1. 7:00 P.M. Agenda For The June Meeting Of The Zoning Board Of Appeals

1.I. Appeal 2232 - 22 Durkee St - SUP

<u>APPEAL</u>	<u>APPLICANT</u>	<u>REQUEST</u>
2232	CITY OF PLATTSBURGH 22 DURKEE STREET	SPECIAL USE PERMIT TO AMEND THE BOUNDARIES OF AN EXISTING PLANNED UNIT DEVELOPMENT AND A SPECIAL USE PERMIT FOR USE OF APARTMENTS ON THE FIRST FLOOR OF A MULTI-STORY BUILDING WITHIN A PLANNED UNIT DEVELOPMENT

C-01

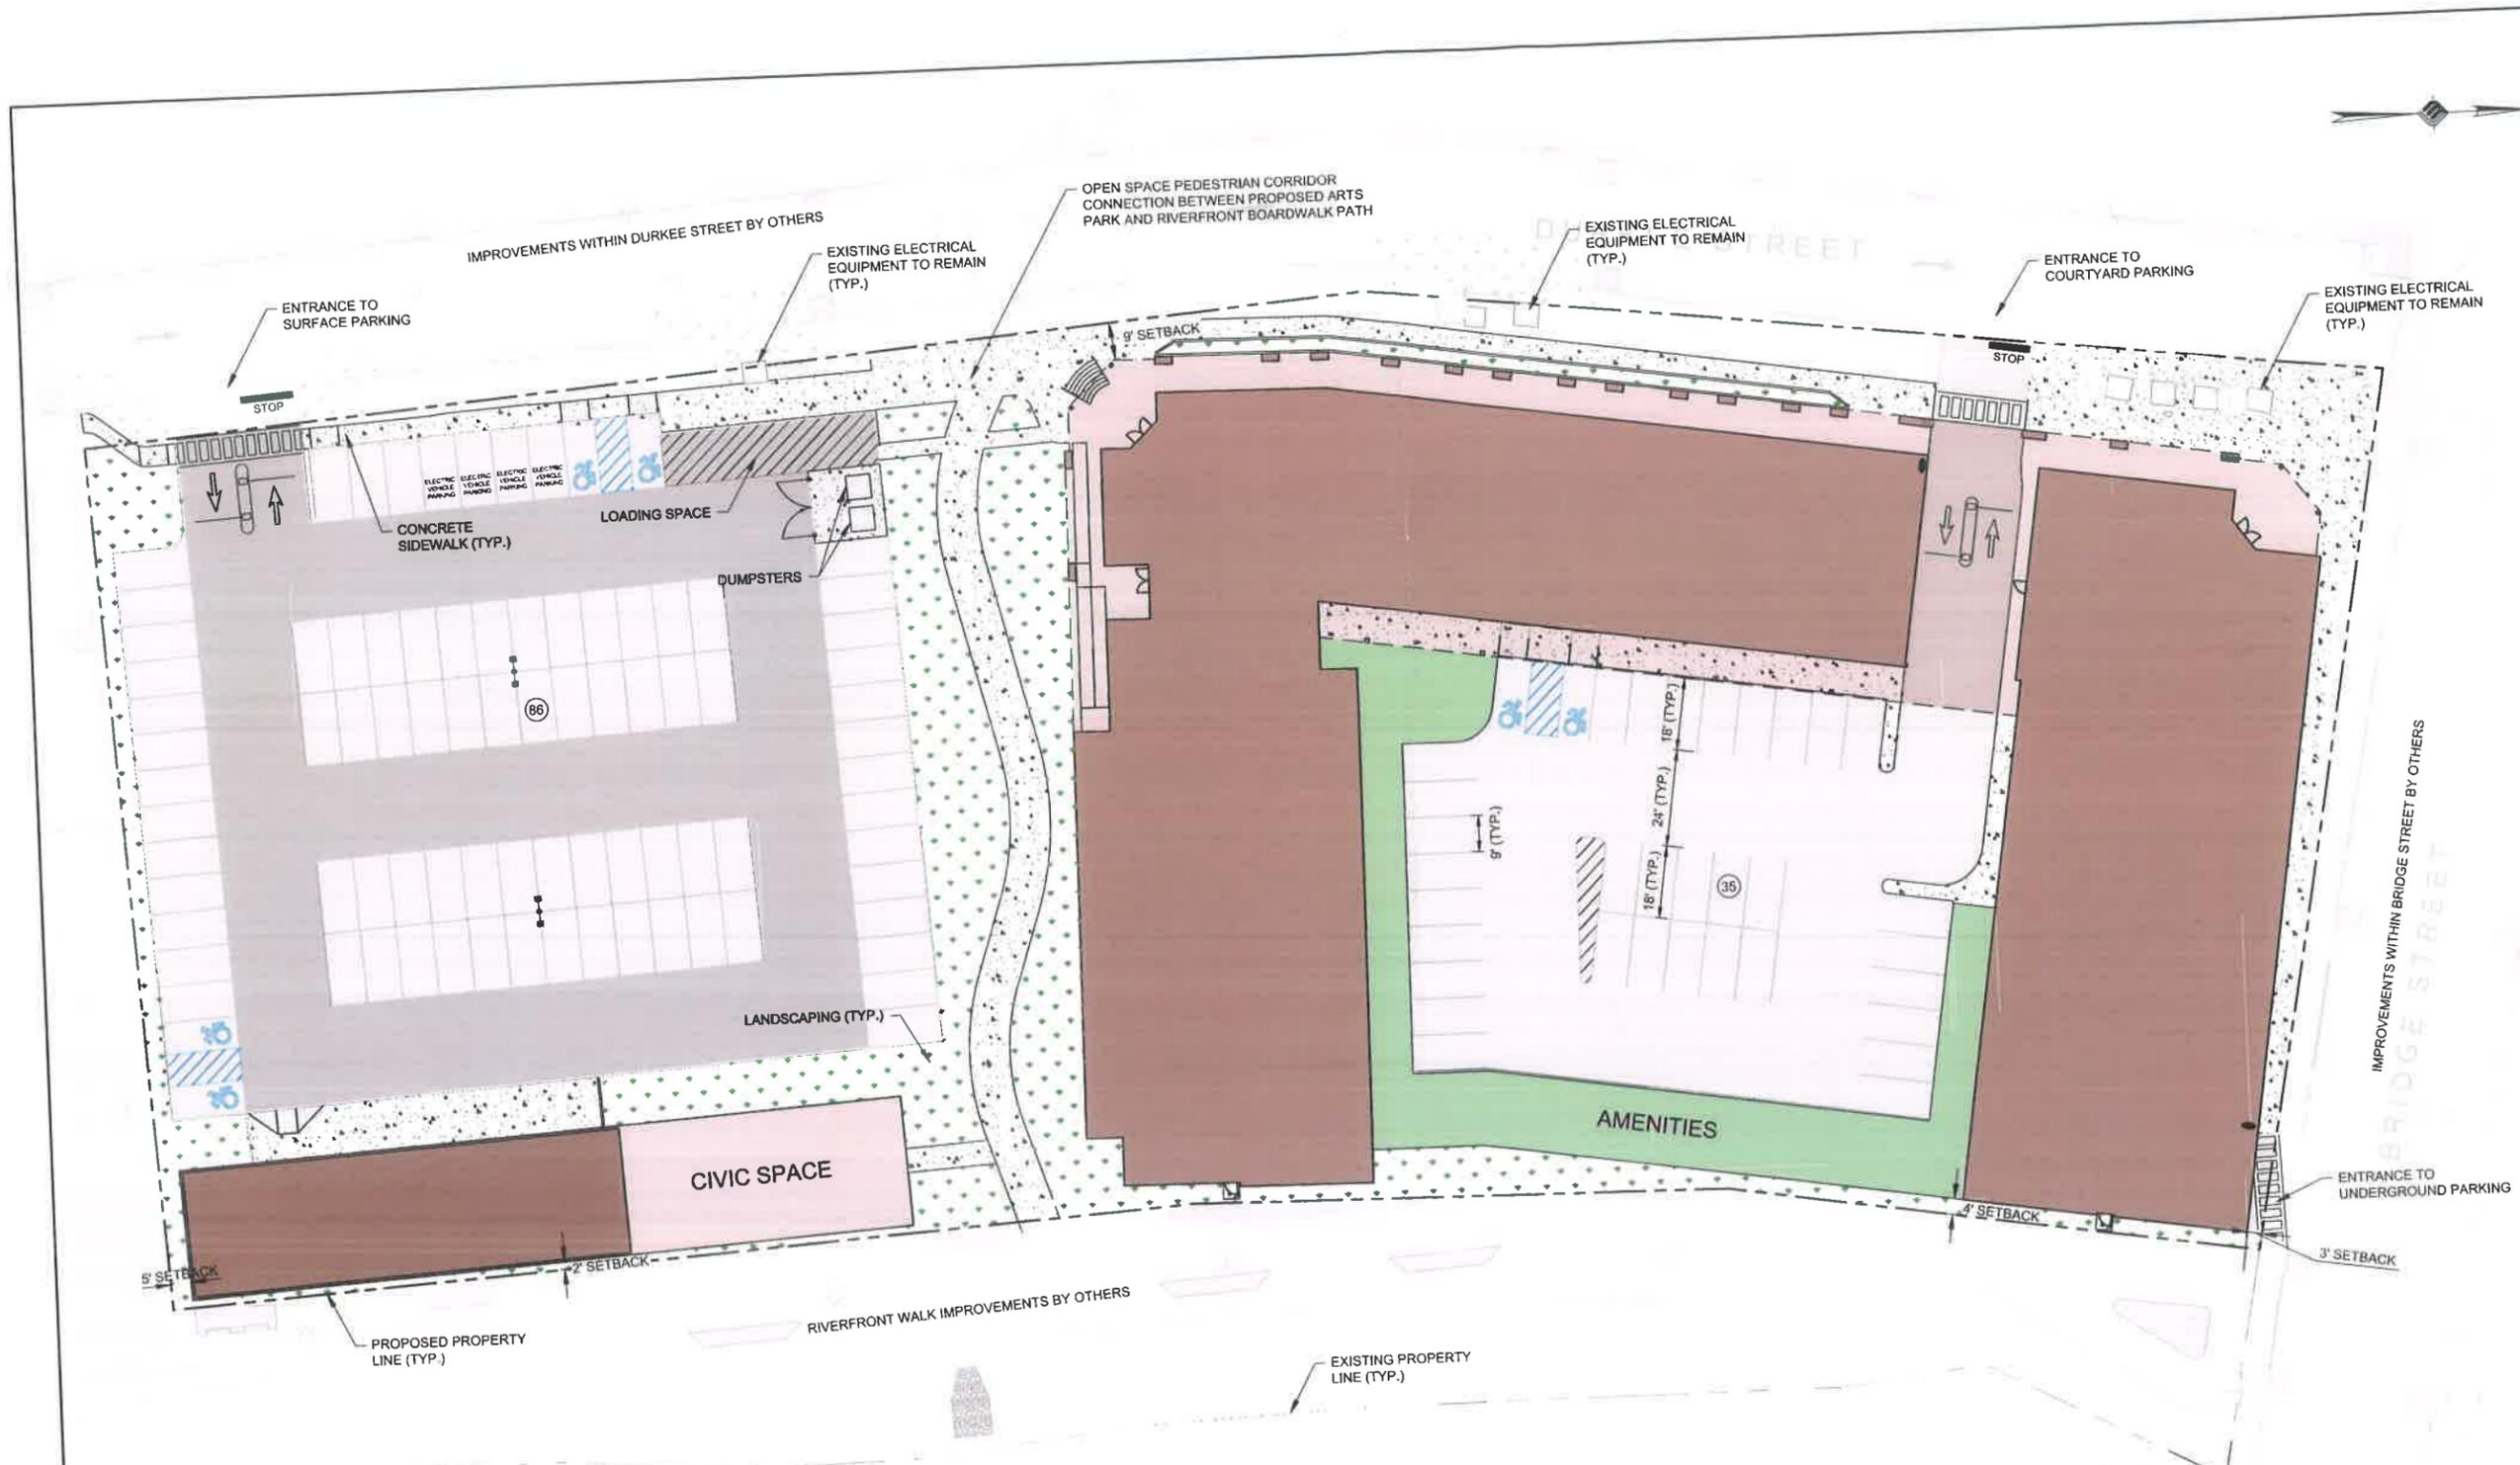
9. Please add dimensions to all existing and proposed buildings, parking areas, and public spaces (sidewalks and pedestrian corridor).
Dimensions have been added to the Site Plans and are shown on sheet C-01.

10. Please show all required/provided setbacks.
Setbacks have been added to the Site Plans and are shown on sheet C-01.
11. Please provide a stormwater management plan, which complies with NYSDEC stormwater regulations.
A full Stormwater Pollution Prevention Plan (SWPPP) has been prepared and is included with this submission.

DRAWING NUMBER
EC-01
 12 OF 20

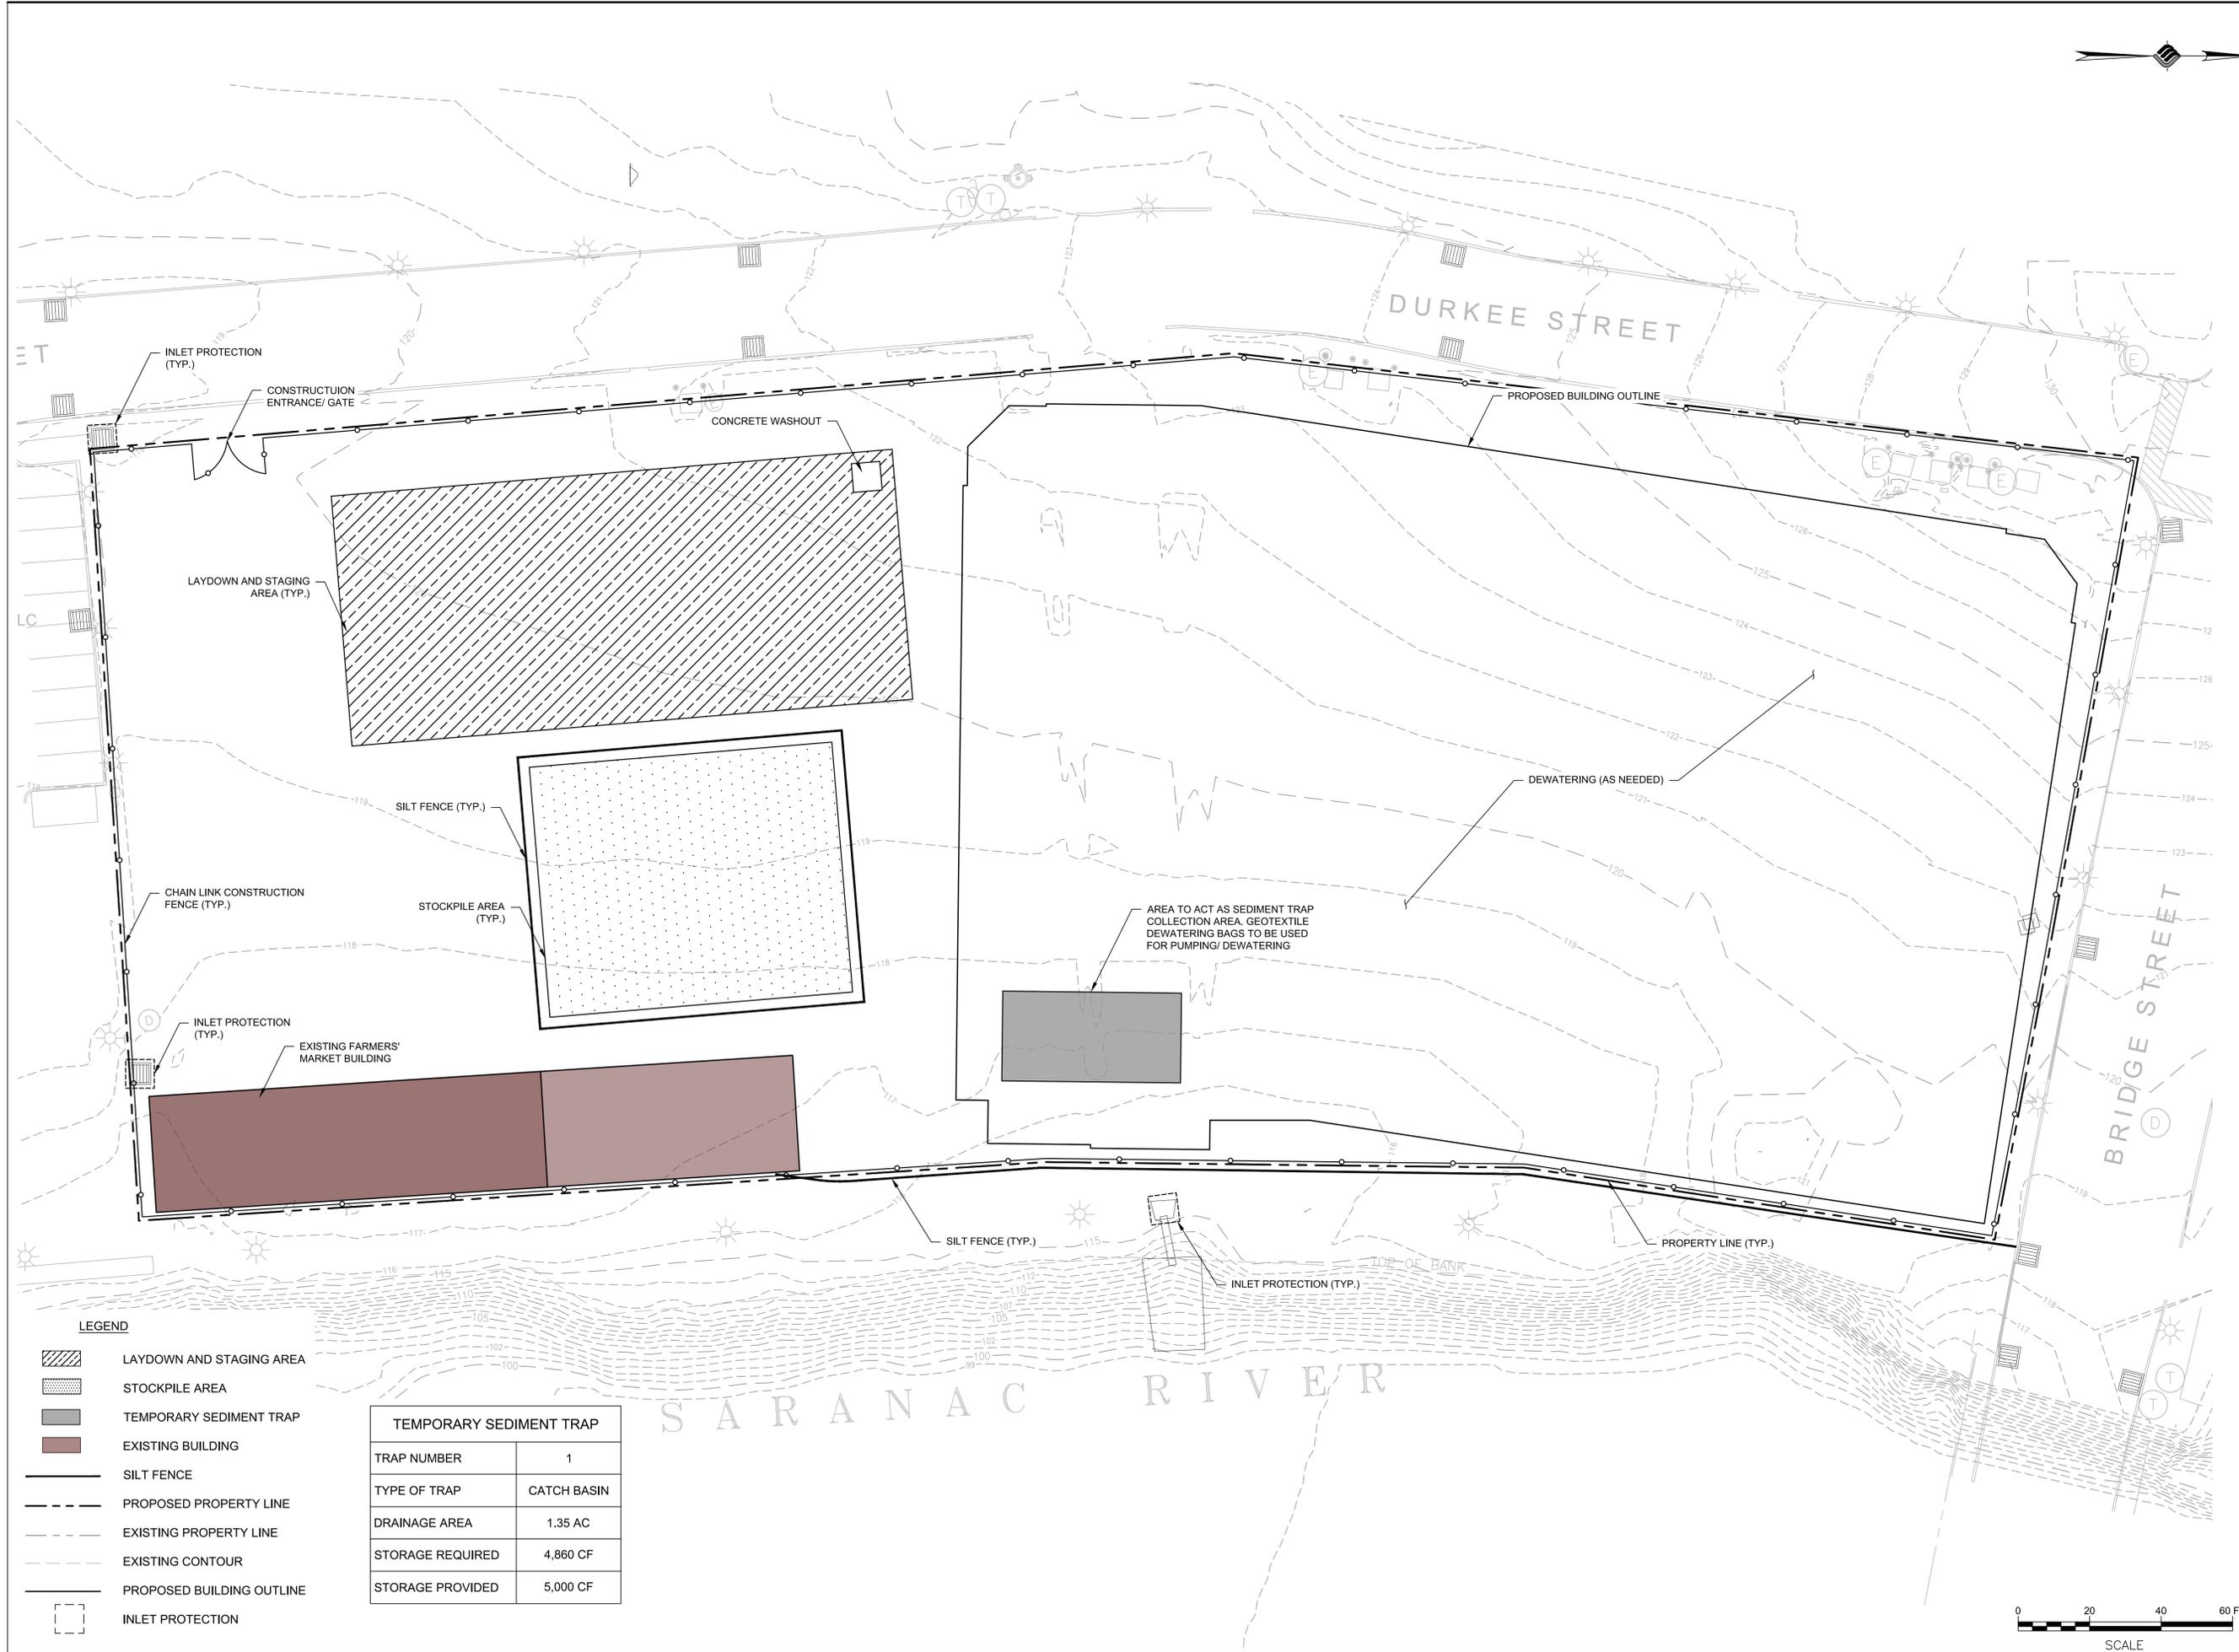
18. Please provide an erosion control plan.
Erosion control plans provided, see sheets EC-01 and EC-02.
19. It is recommended that the Applicant be required to show proposed snow stockpile areas on the plan.
Snow stockpile areas have been provided and are shown on Site Plan sheet C-01.

DRAWING TITLE
DETAILS
 DRAWING NUMBER
DT-06

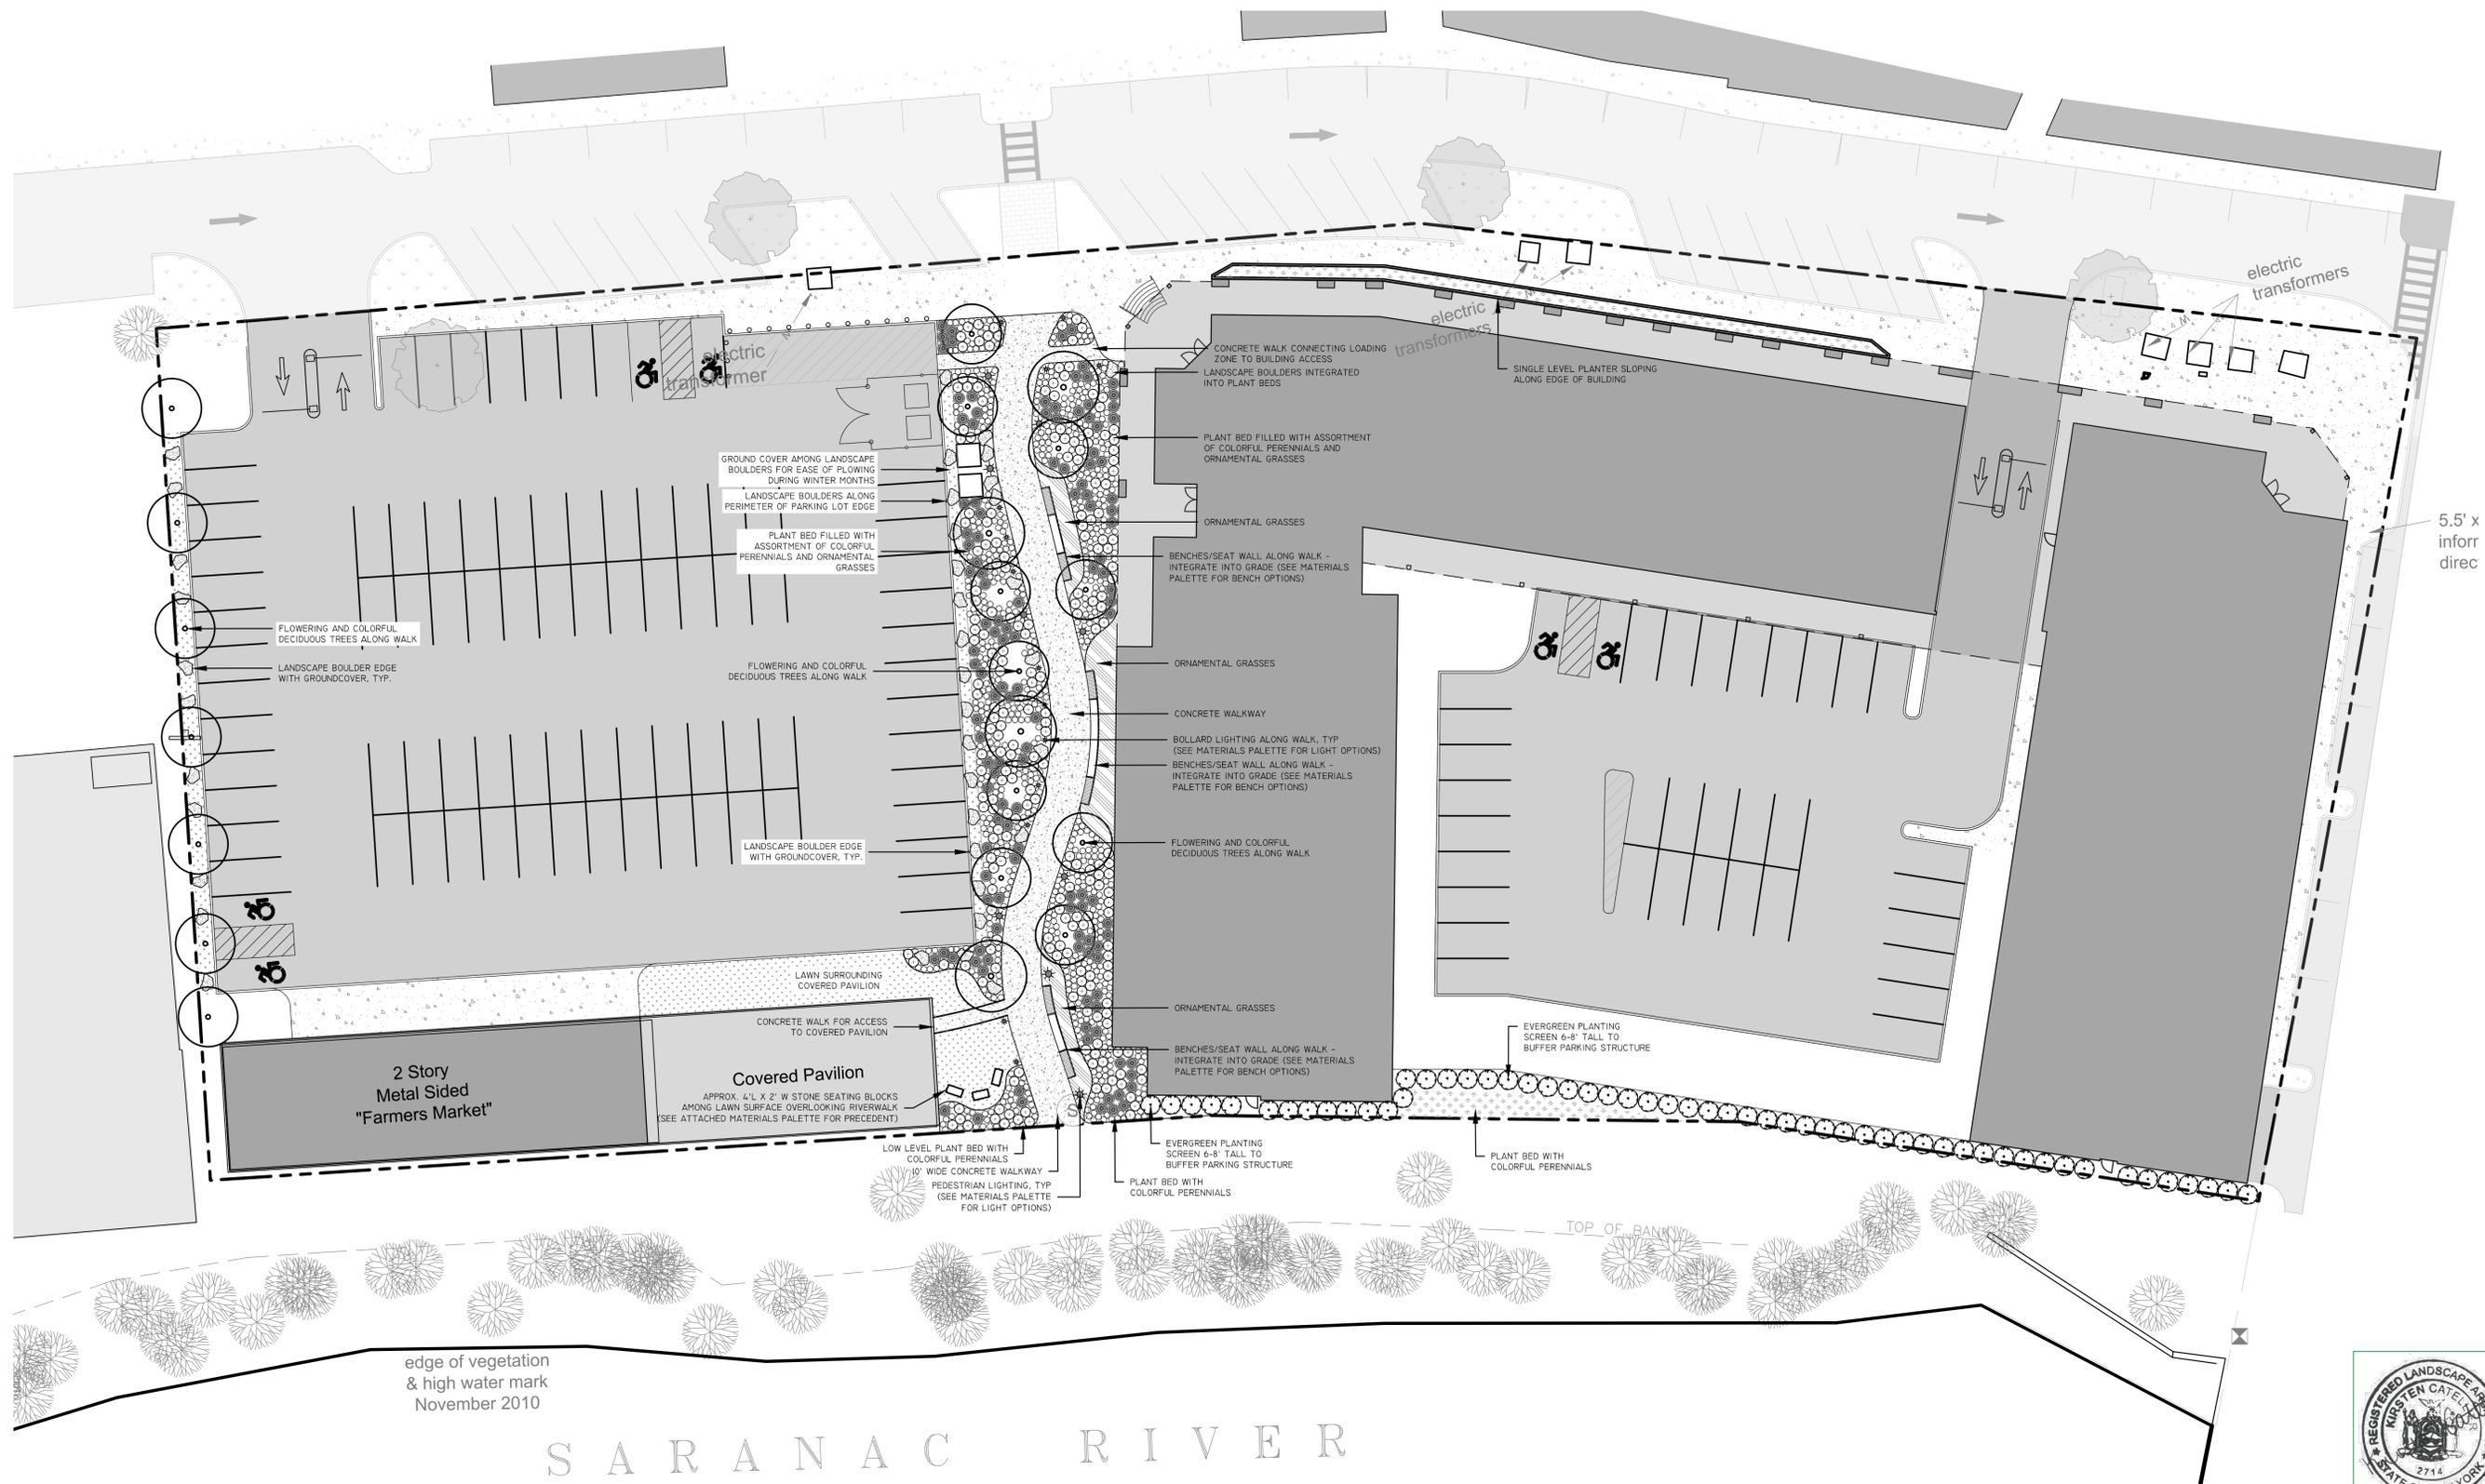
31. Please provide a details sheet showing all on-site signage, landscaping, driveway and sidewalk details, etc.
Details are provided, see sheets DT-01 through DT-06.
